**NELSON GEOTECHNICAL  
ASSOCIATES, INC.**

Geotechnical Plan Review Letter  
**Hu Residence Development**  
**30XX – 69<sup>th</sup> Avenue SE**  
**Mercer Island, Washington**  
NGA File No. 11448B20

Figure 10

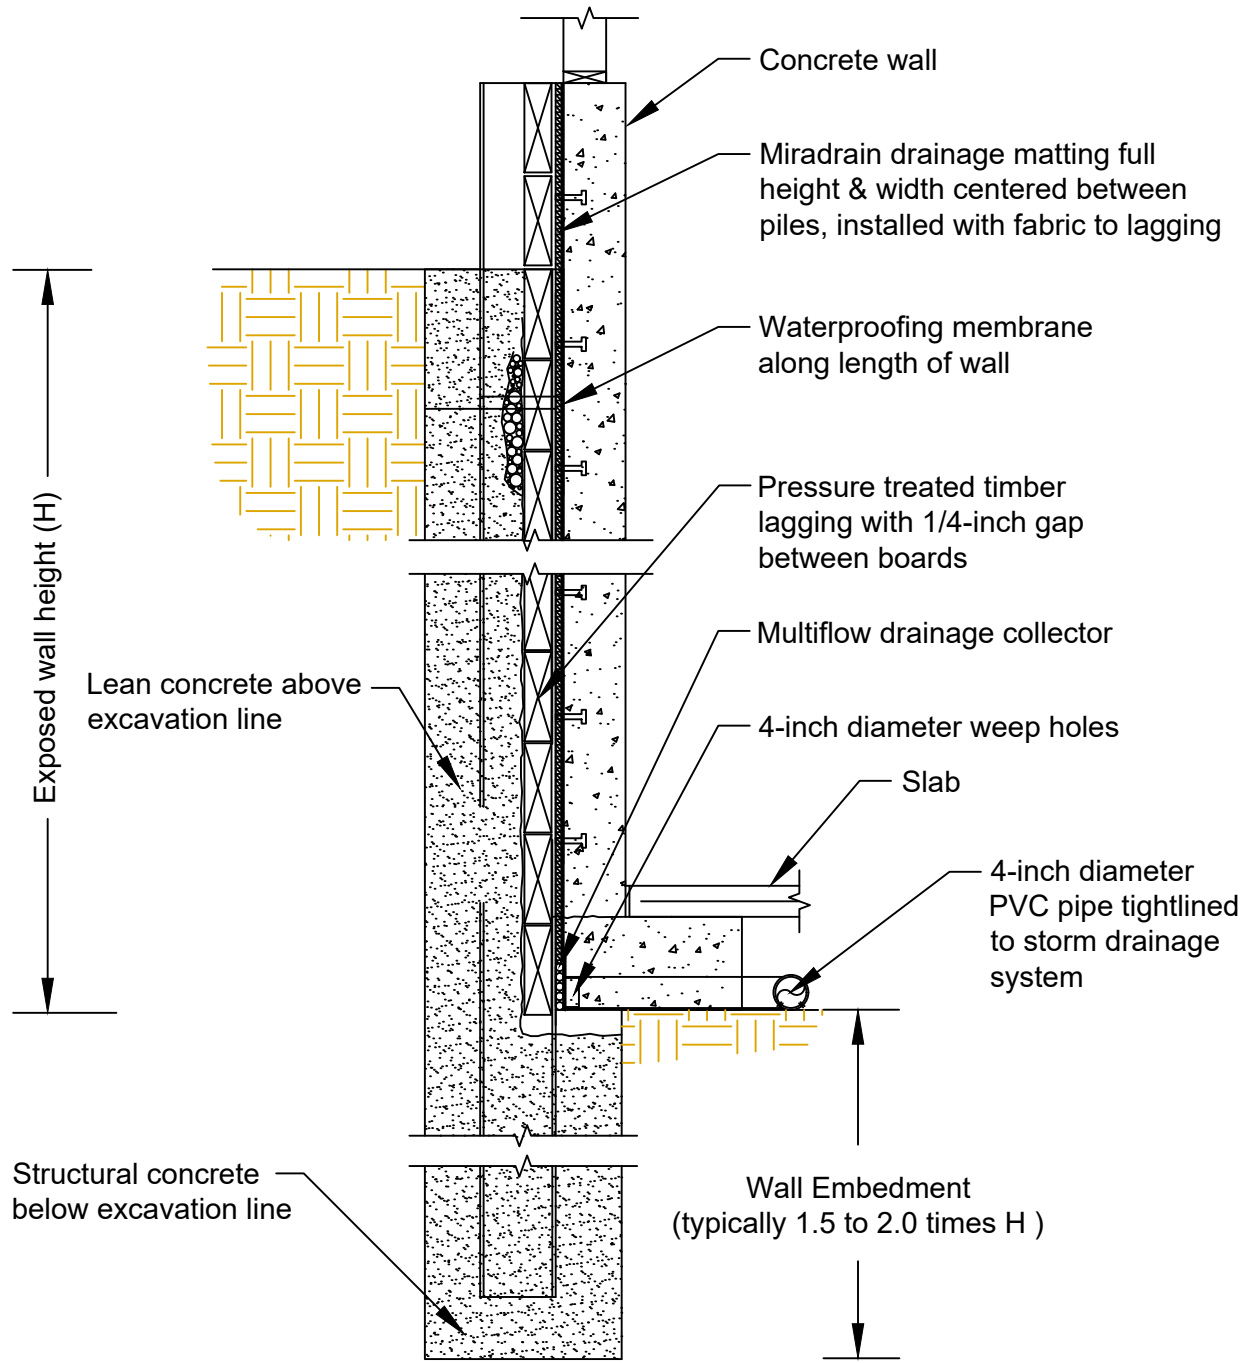
A City review comment on **Sheet A-4.01** concerns drainage recommendations for permanent shoring walls and requests the geotechnical engineer to provide those recommendations. Drainage composite should be placed against the full height of the shoring lagging and should be hydraulically connected to weep holes that extend through the base of the permanent wall facing. Those weep holes should be spaced 8 feet on center and should be tightlined to the stormwater system. The shoring wall drainage recommendations are illustrated in Figure 10 which is attached to this letter. Detail 1 on Sheet **A4.01** incorporates those drainage recommendations into project plans.
